**Britt T. McKinney**  
Sr. Vice President & Chief Nuclear Officer

**SUSQUEHANNA STEAM ELECTRIC STATION  
REQUESTS FOR ADDITIONAL INFORMATION (RAI) FOR THE  
REVIEW OF THE SUSQUEHANNA STEAM ELECTRIC STATION,  
UNITS 1 AND 2 LICENSE RENEWAL APPLICATION (LRA)  
SECTIONS 2.2 AND 2.3  
PLA-6257**

**Docket Nos. 50-387  
and 50-388**

**Enclosure to PLA-6257  
PPL Responses to NRC's  
Request for Additional Information (RAI)**

**Revised Boundary Drawing LR-M-157 Sheet 4**

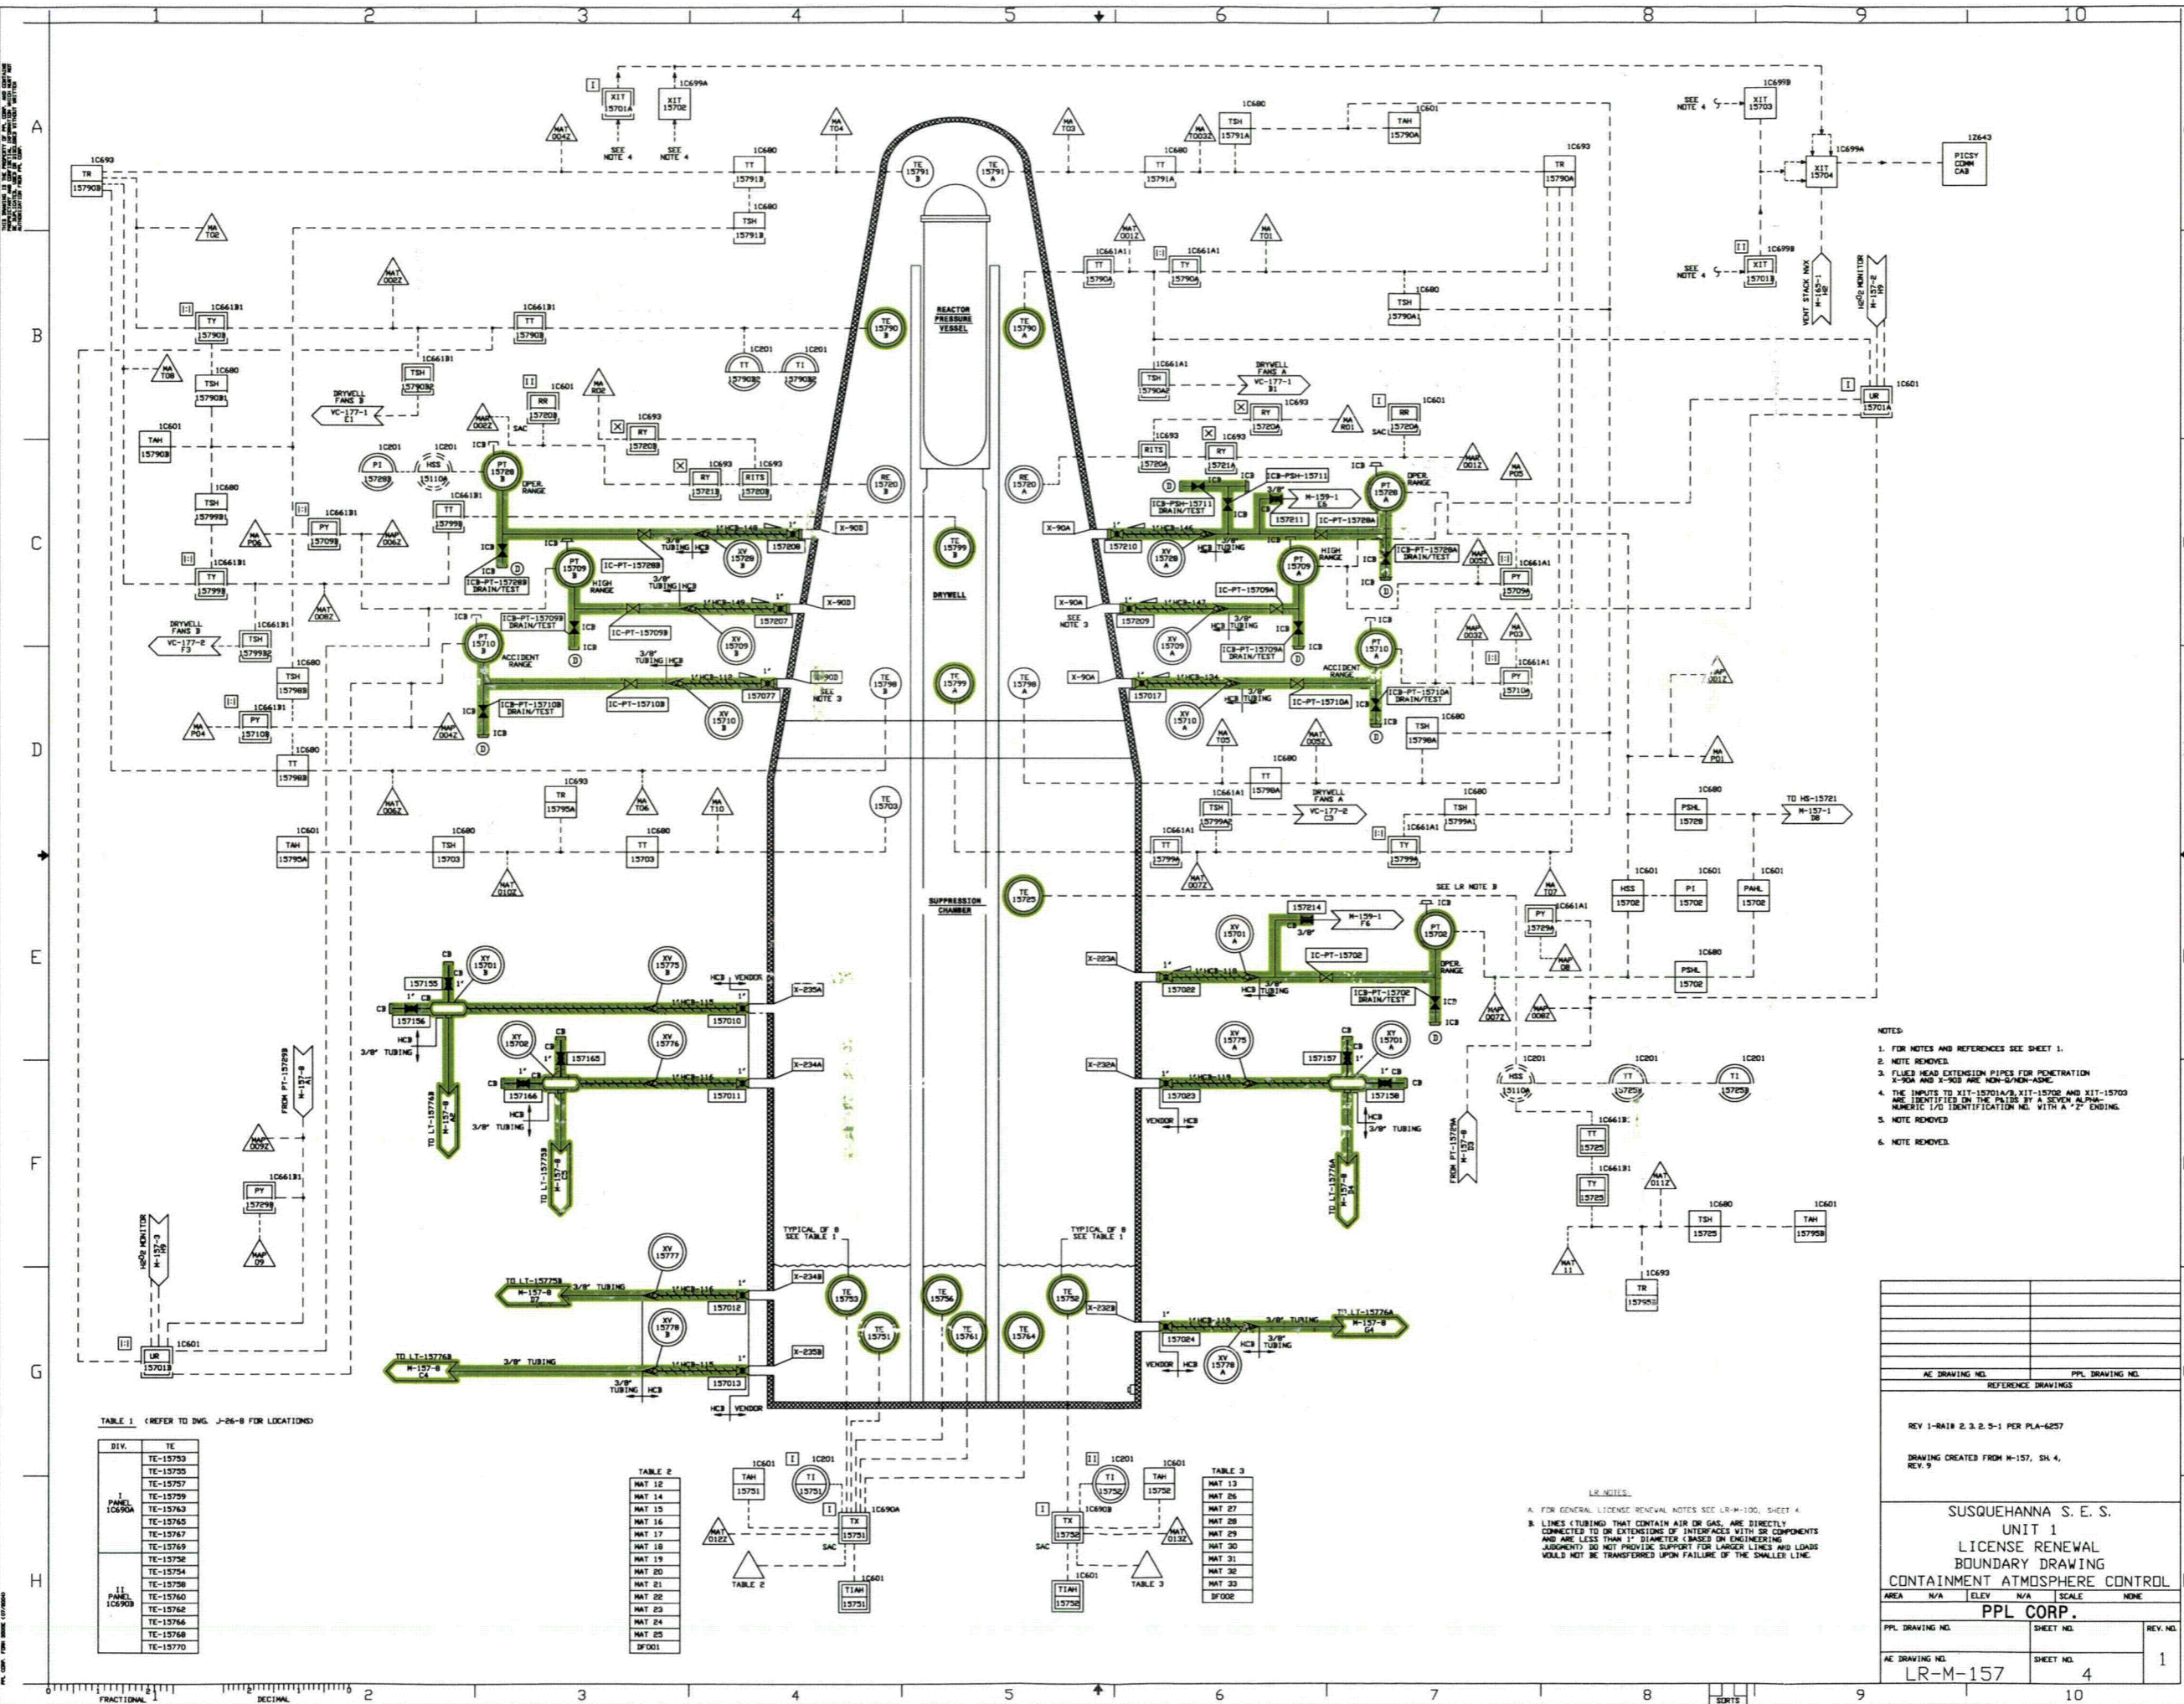
Drawing No. LR-M-157, Sheet 4, 1-inch valve 157011 at penetration X-234A and 1-inch valve 157023 at penetration X-232A which belong to suppression pool level monitoring system are shown as not in scope for license renewal.

Provide justification for the exclusion of these valves from the scope of license renewal. If these valves are in the scope of license renewal, in accordance with 10 CFR 54.4(a), and subject to an aging management review in accordance with 10 CFR 54.21(a)(1), update the LRA by providing the applicable information in the appropriate LRA Sections, tables, and drawings.

Boundary drawing LR-M-157 sheet 4 contained an error related to highlighting. Valve 157011 at penetration X-234A and valve 157023 at penetration X-232A are both in-scope and subject to aging management review, but they were inadvertently not highlighted. Both valves have been highlighted in green on the revised boundary drawing LR-M-157 sheet 4, included as Attachment 1.

In the course of addressing this RAI, it was also noticed that the highlighting at penetration X-90D for 1-inch line HCB-112 was slightly different from the highlighting for the other pipelines at penetrations X-90A and X-90D. The short length of piping between valve 157077 and the penetration should have been highlighted. This piping is in-scope and subject to aging management review, but was inadvertently not highlighted. This piping has been highlighted in green on the revised boundary drawing LR-M-157 sheet 4, included as Attachment 1.

**Revised Boundary Drawing LR-M-157 Sheet 1**

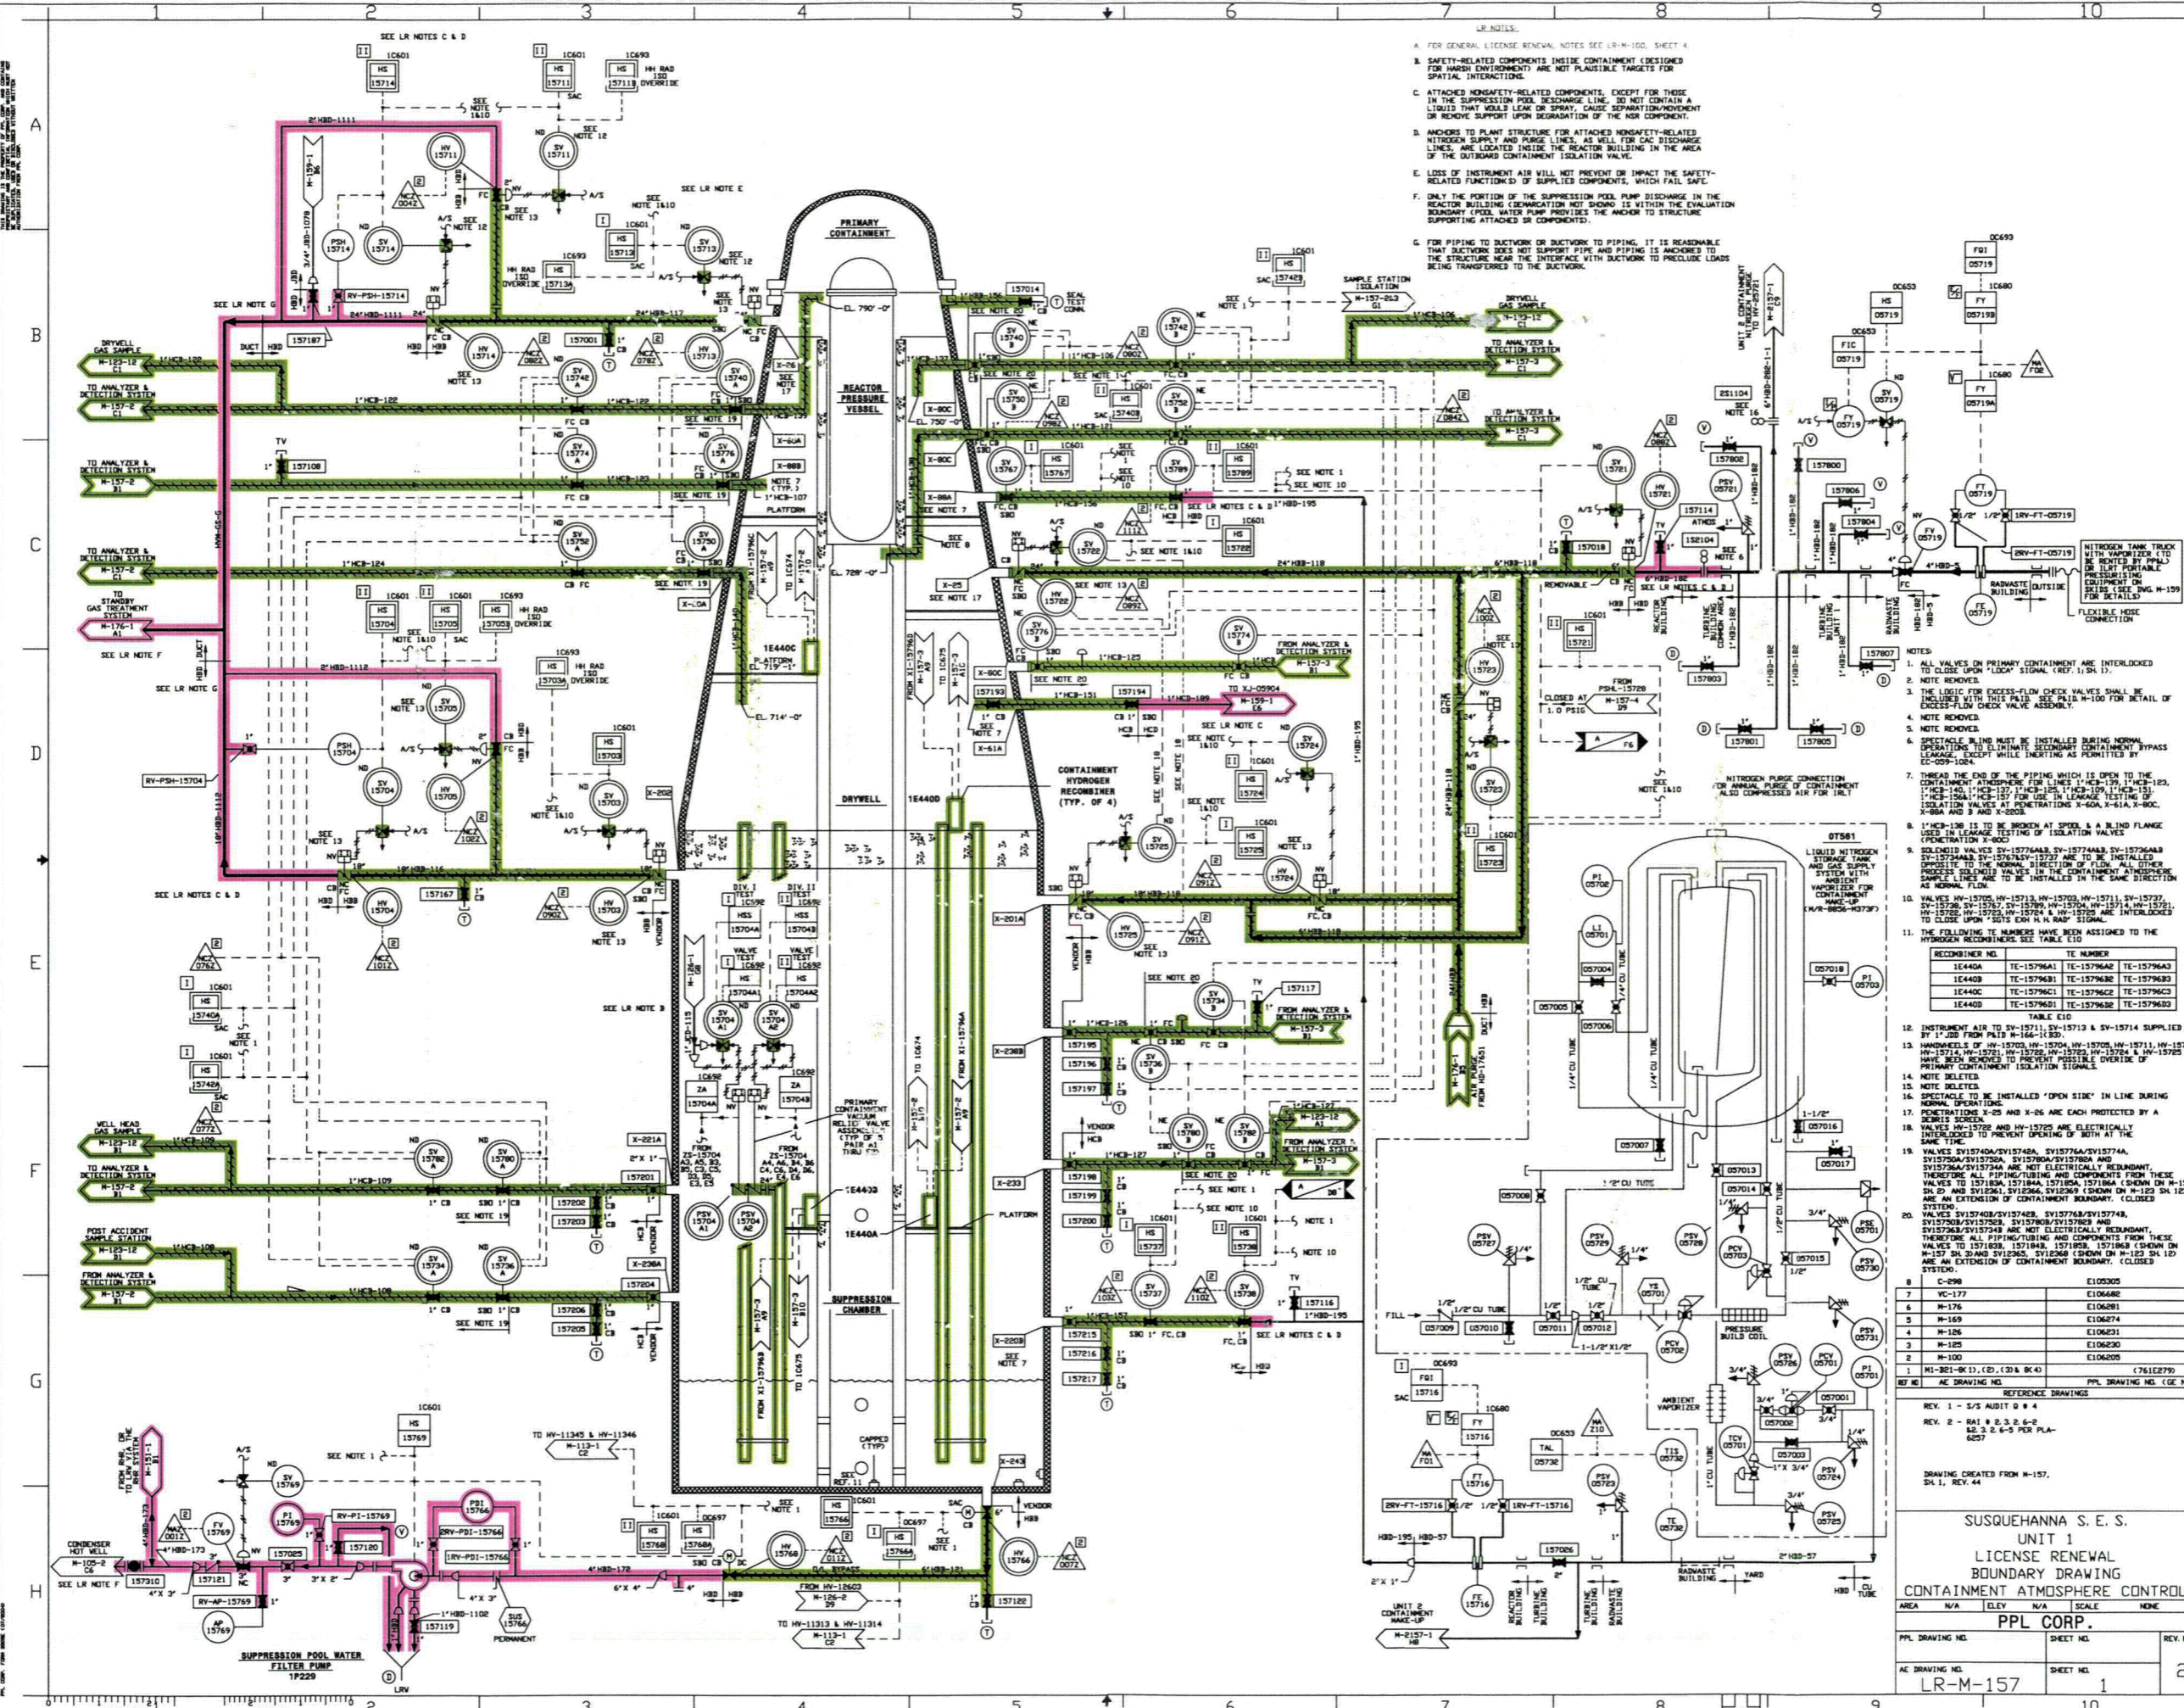
FSAR Table 6.2-12, "Containment Penetration Data" shows the 24-inch butterfly valve HV15722 as a containment isolation safety-related valve located at drywell penetration X-25. This valve located in zone C-5 of drawing No. LR-M-157 Sheet No. 1 is shown as not in scope of license renewal.

Provide justification for the exclusion of this valve from the scope of license renewal. If this valve is in the scope of license renewal, in accordance with 10 CFR 54.4(a), and subject to an aging management review in accordance with 10 CFR 54.21(a)(1), update the LRA by providing the applicable information in the appropriate LRA Sections, tables, and drawings.

Drawing LR-M-157, sheet 1, zone F-3, at primary containment penetration X-221A shows the piping component at the upstream side of valve 157201 as not in scope for license renewal.

Provide justification for the exclusion of this piping component from the scope of license renewal. If this component is in the scope of license renewal, in accordance with 10 CFR 54.4(a), and subject to an aging management review in accordance with 10 CFR 54.21(a)(1), update the LRA by providing the applicable information in the appropriate LRA Sections, tables, and drawings.

Boundary drawing LR-M-157 sheet 1 contained an error related to highlighting. Valve 157022 and the short length of piping between the valve and penetration X-25 are in-scope and subject to aging management review, but they were inadvertently not highlighted. The valve and the piping have been highlighted in green on the revised boundary drawing LR-M-157 sheet 1, included as Attachment 4.

Boundary drawing LR-M-157 sheet 1 contained an error related to highlighting. Valve 157201 at penetration X-221A has a 2-inch by 1-inch reducer that is in-scope and subject to aging management review, but it was inadvertently not highlighted. The reducer has been highlighted in green on the revised boundary drawing LR-M-157 sheet 1, included as Attachment 4.
